City of Poughkeepsie
Zoning Board of Appeals
Meeting Agenda

Tuesday, December 9, 2025

RE: 101 south grand Ave, Poughkeepsie NY 12601
Tax parcel 131300-6161-49-586580-0000

Attached is a revised site plan revised per the city's review email dated 08/04/25.
We offer the following responses to the review comments:

PROPOSED DRIVEWAY IMPROVEMENT PLAN

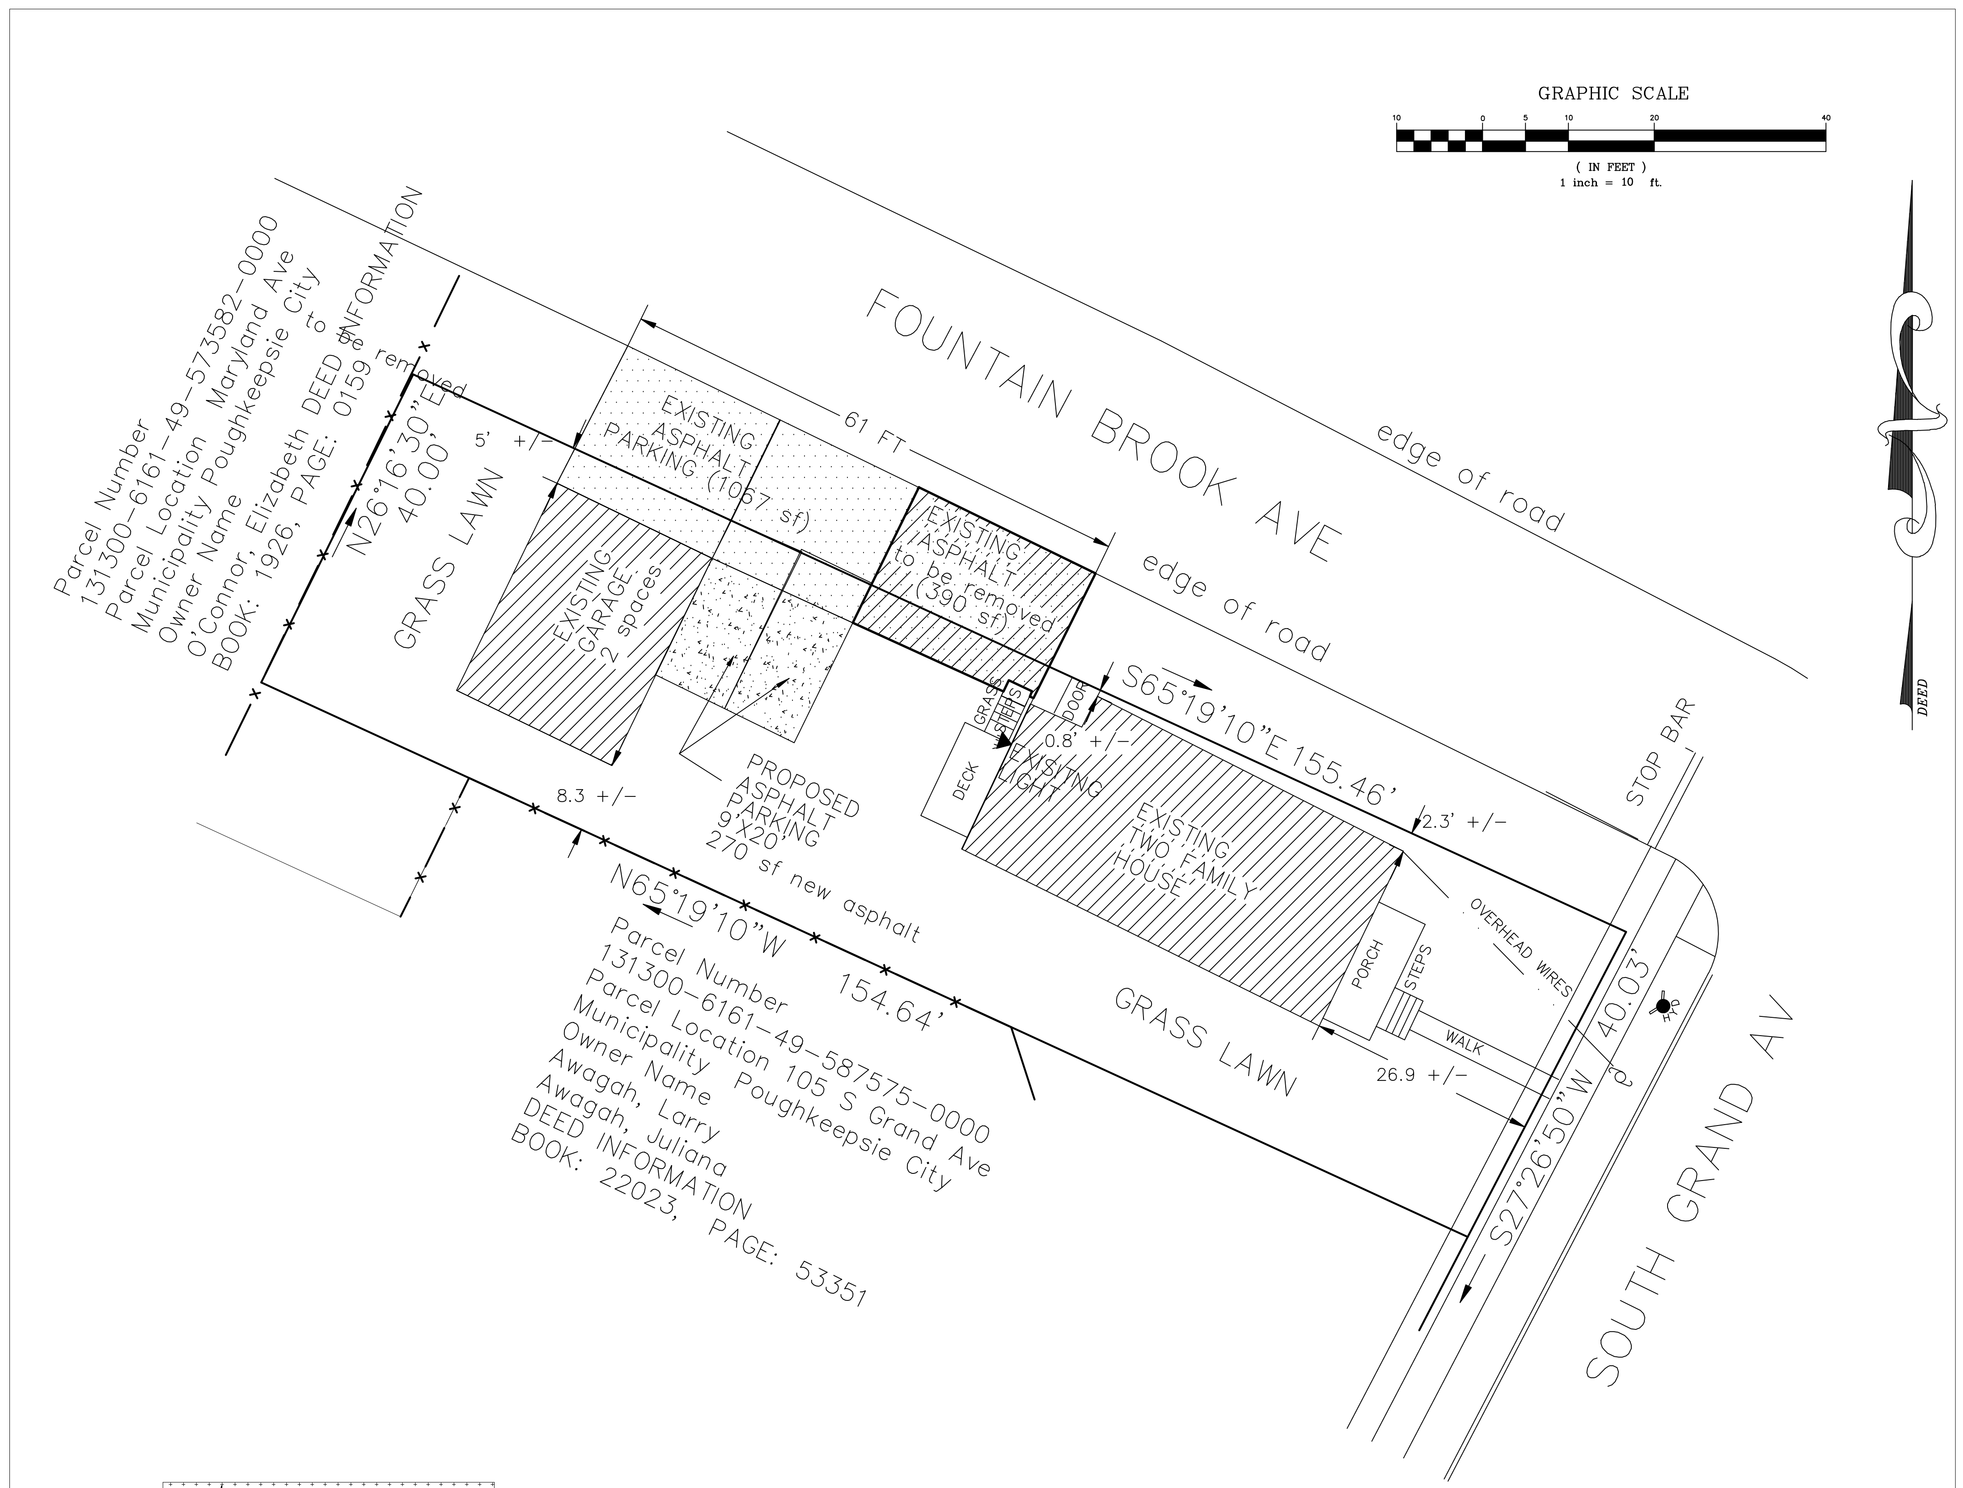
1) Section 19-2.1(2) provides for a maximum driveway width of 15 feet: as all parking spaces have direct access/egress to the street, the driveway is 56 to 60 feet wide;
Response: Two new parking spaces are shown limiting site to 4 spaces when using two spaces within the garage. The existing asphalt is 61 feet long but the two spaces shown are 9' x 20'. The owner of the parcel does not want to remove existing asphalt and is requesting a variance of 46 feet so the existing asphalt can remain, while the two new spaces will be 9 feet wide each.
Variance is being requested and an application is enclosed.

2) Section 19-6.2(1)(g) requires that off-street parking areas shall be adequately illuminated for convenience and safety (but not glare on adjoining properties): no lighting is proposed;
Response. The existing site has a light on the rear of the building illuminating the spaces. The light has been added to the map,

3) Section 19-6.2(4)(b) requires that where a parking area for three or more vehicles faces a property line, a planting area a minimum of three feet high and three feet wide planted three feet on center shall be provided between the parking area and the street or property line: no landscaping is proposed along the south property line;
Response: The asphalt parking has access directly onto the street and there is no place to place landscaping. The area behind the parking space is grass lawn as is most areas in the neighborhood. A variance to not provide landscaping is being requested.

4) Section 19-6.2(9) provides that the number of parking spaces provided shall be no more than 120% of the total required: Four spaces are required, while between the two-bay garage and the four new spaces, a total of six (6) parking spaces are provided, 150% more than required.
Response: The revised plans show 4 spaces, two outside and two inside of garage. The existing pavement is more than the 120% allowed so a variance is being requested
Allowed parking required for 4 spaces is 720 sf, 120% of 720 sf = 864 sf
Existing asphalt area 1067 sf and two new spaces 240 sf = total 1304 sf or 181%
Variance of 440 sf being requested.

DRAWING
PROPOSED ELEVATIONS

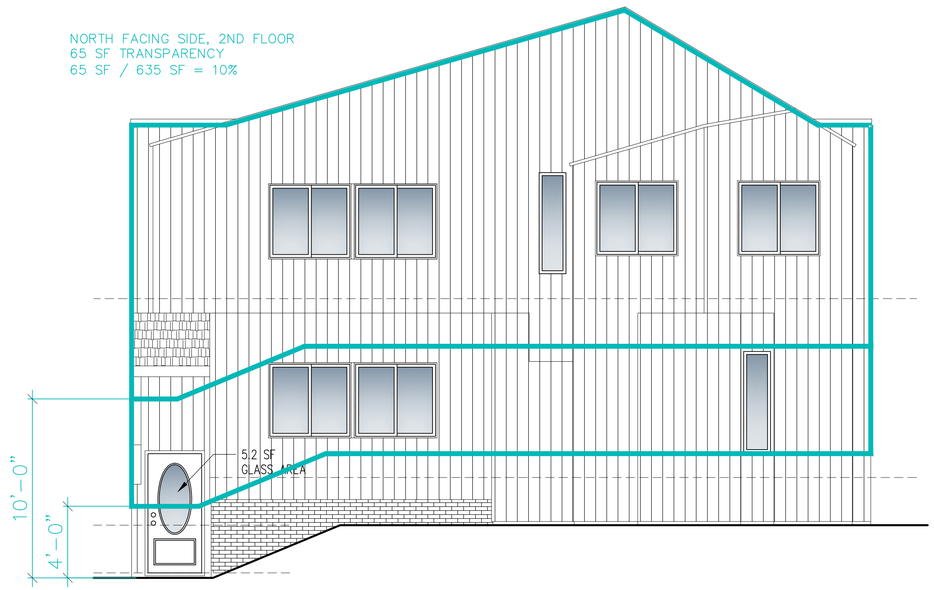
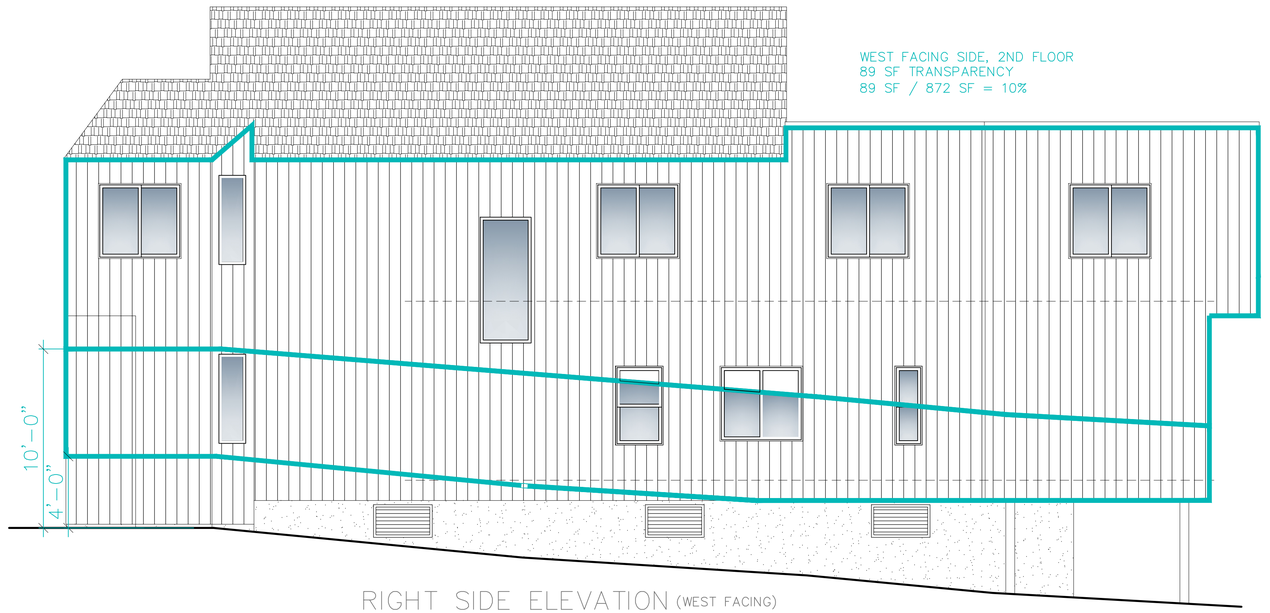
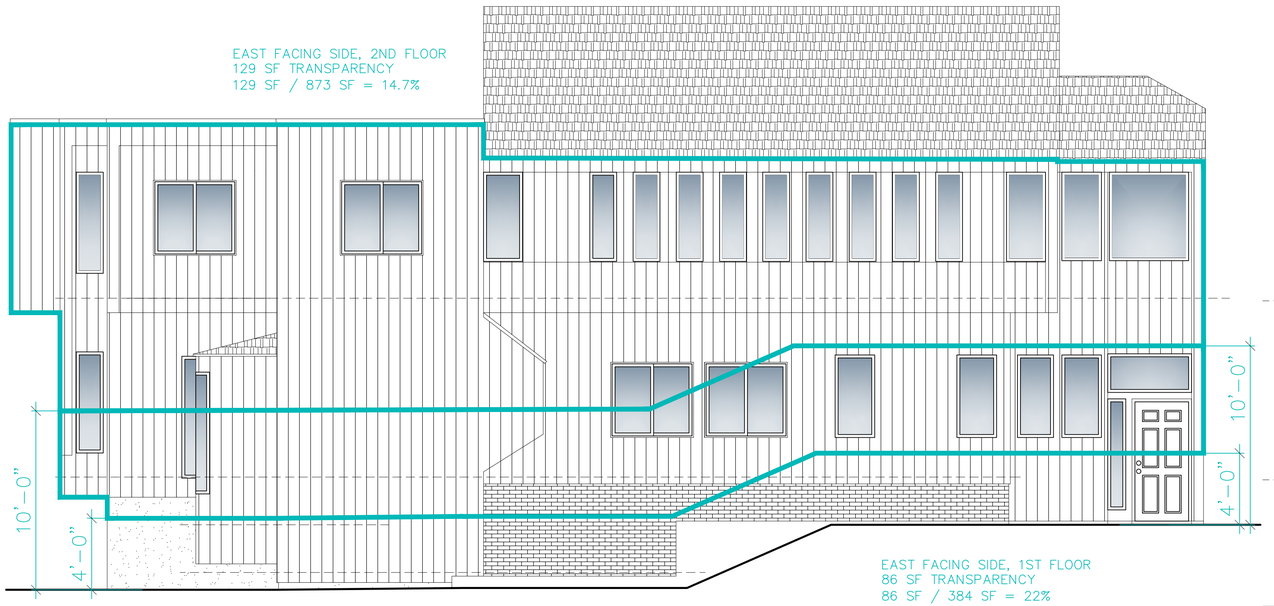
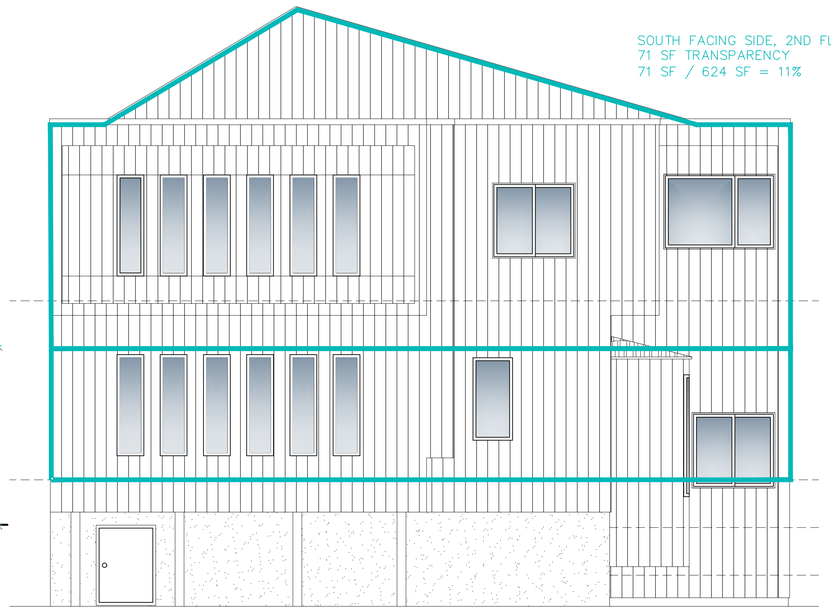
The Development Department is in receipt of your revised site plan for review relative to the proposed conversion of the vacant office building at 136 Parker Avenue to a five-unit multiple dwelling. The property is located in an area of the City zoned Walkway-Gateway (W-G) District. A review of the proposal for compliance with the provisions of the W-G District relative to such a use reveals the following deficiencies:

The existing building cannot provide the required transparency without extensive structural work and major interior modifications that would prove cost-prohibitive.
